<u>SP-24-09</u>	<b>Staff Report – July 29, 2024</b>
<b>Application Type:</b>	Special Use Permit
<b>Project Address:</b>	1601 Lemoyne Avenue (Tax Map ID: 004.-05-03.0), 1611 Lemoyne Avenue To City Line, (Tax Map ID: 004.-05-02.0), 1585 Lemoyne Avenue (Tax Map ID: 004.-05-04.1)
<b>Summary of Proposed Action:</b>	<p>The applicant (Cuse Car Care, LLC.) proposes to change the land use from a heavy automobile repair use type to a light automobile repair use type and build a 2,920 SF (footprint) addition onto the existing building. The existing heavy automobile repair use type is a legal non-conforming land use in the Mixed-Use Transition, MX-3 Zone District. The light automobile repair use type is a conforming use and only permitted by a Special Use Permit in the MX-3 Zone District.</p> <p>The applicant also intends to combine three existing lots (1601 Lemoyne Ave., 1611 Lemoyne Ave., and 1585 Lemoyne Ave.) to become one new lot (new 1601 Lemoyne Ave.) for the proposed light automobile repair use and proposed building expansion.</p> <p>The total gross floor area of the proposed building is 5,840 SF (2-story) and the existing building is 3,165 SF (1 story). The total gross floor area of t

SHEET NUMBER  
**L-1**

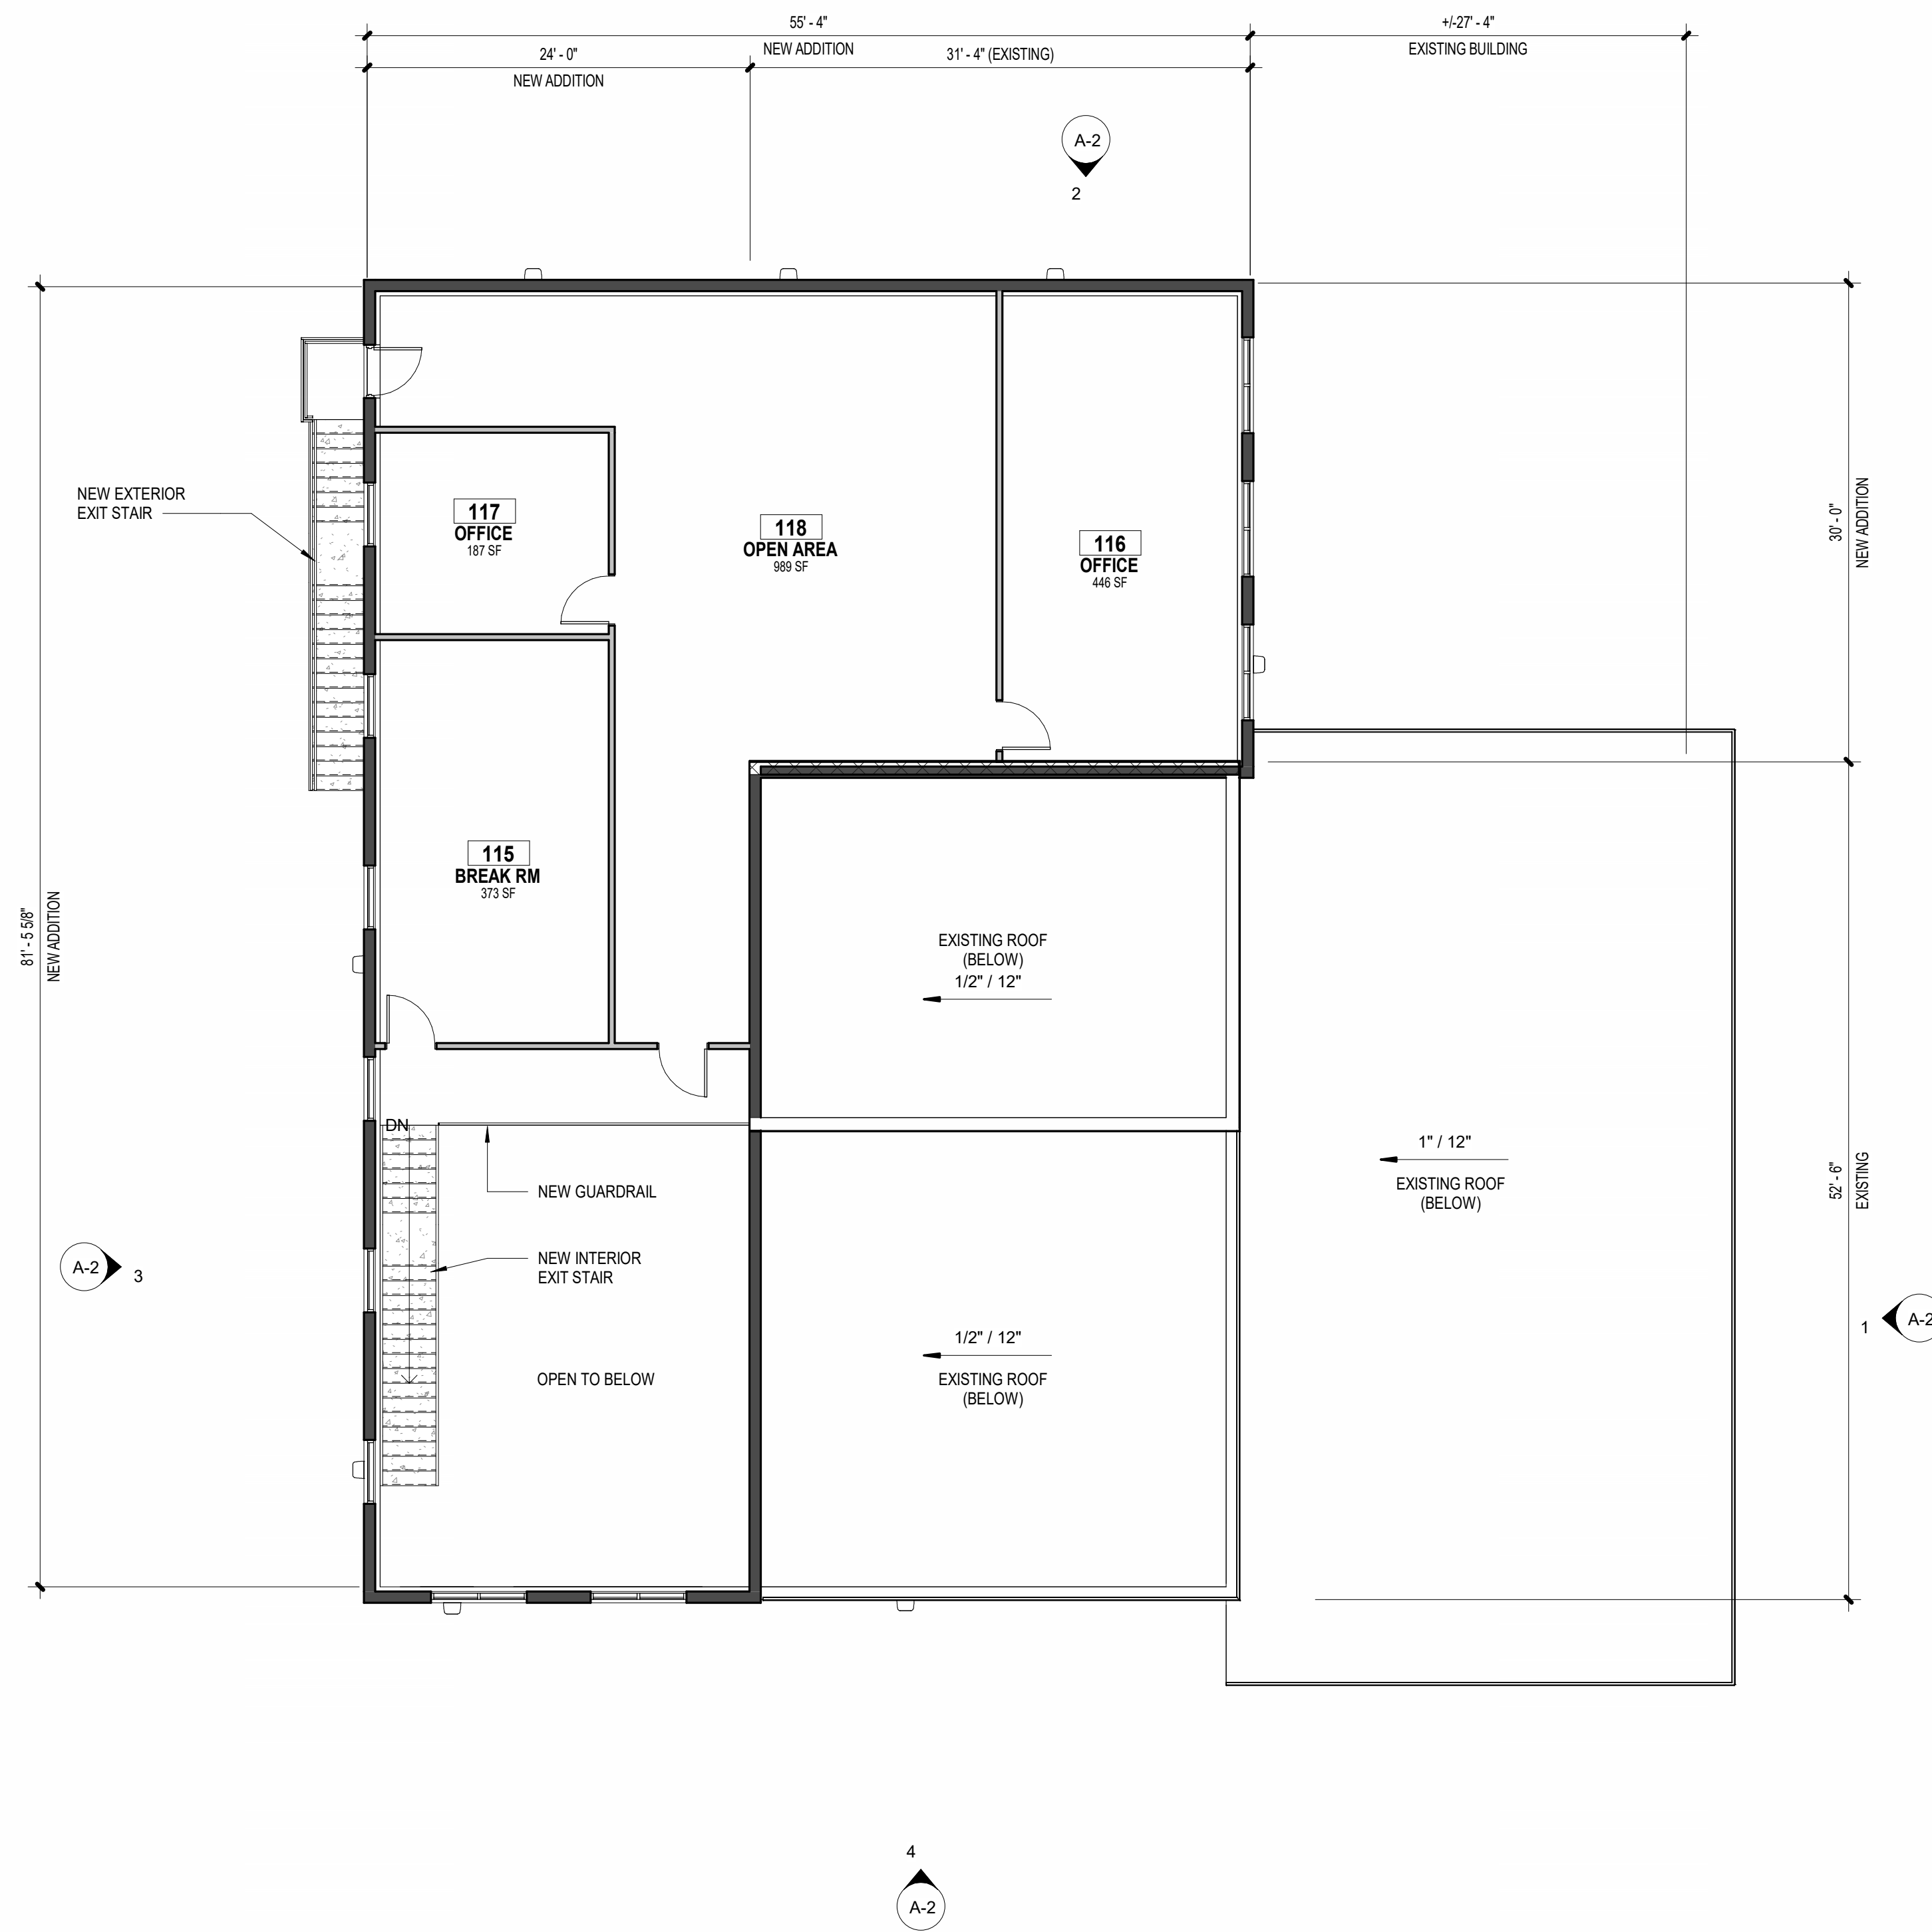
1. The applicant is required to coordinate with the Onondaga County Department of Transportation regarding access plans and establish formal driveway access to LeMoyne Avenue in conformance with commercial driveway standards. The municipality must ensure any mitigation as may be determined by the Department is reflected on the project plans prior to, or as a condition of, municipal approval.
2. The applicant and City must coordinate a multi-municipal review of the proposed project with the Town of Salina.
3. The applicant and municipality are encouraged to improve appearance of the

- Parking area to be curbed/incorporate fixed vertical objects (no wheel stops) along all sides.
- Parking area to incorporate greenspace buffer, 5' or greater along entirety of Lemoyne ave frontage outside of driveway opening, measured inwards from property line. To include perirenal plant material/trees/etc.
- Planting plan required, grading/drainage plan may impact/increase buffer requirements.
- ADA compliant walkway to/from the main entrance and public ROW/sidewalk required, typically aligned with loading area of accessible parking stalls.

DPW - Sanitation & Sewers	On Hold	04/17/2024	Vinny Esposito	<p>please provide a drainage plan, The site will be nearly 100% impervious as per plan. Storm water must be mediated to an extent, dry wells or re-charge trenches. Also the sewer in the 20' ROW must be located precisely as I believe this is a 30" storm sewer.</p>
DPW - Traffic Control	Conditionally	04/23/2024	Charles	4.23.24 Conditionally Approved.

Approved		Gafrancesco	No sidewalk closures or obstructions or road or lane closures will be allowed as part of this work unless accompanied by MUTCD compliant detour.
Zoning Planner	On Hold	04/17/2024	Haohui Pan	Updated plan needs: The east side of the building that abutting the adjacent Residential Zone shall be fenced.
Engineering - Stormwater (SWPPP)	Conditionally Approved	04/25/2024	Mirza Malkoc	<ul style="list-style-type: none"> <li>• All construction in the R.O.W. will require a road cut permit, all construction in the R.O.W. to be per City standards and specifications.</li> <li>• Complete set of the stamped engineering site plans with specific details are required to complete a detailed project permit review.</li> <li>• Designer shall clearly indicate on the site plans how much soil disturbance this project will create. If the soil disturbance is over 10,000sf then a SWPPP is required but if the soil disturbance is less than 10,000sf then the designer need to do some improvements to the site by capturing the stormwater sheet flow and treating it before discharging it to the City's ROW.</li> <li>• Proposed grading shall be graded to prevent stormwater sheet flow to adjoining properties &amp; to the City R.O.W.</li> <li>• The Project is subject to Onondaga County's 1:1 offset. The City requires an offset plan &amp; details for review. Applicant shall submit sanitary flow data to the Engineering Department, the determined offset plan then most likely will require Common Council Approval.</li> <li>• Onondaga County Plumbing Control shall review and approve the plans as well.</li> </ul>
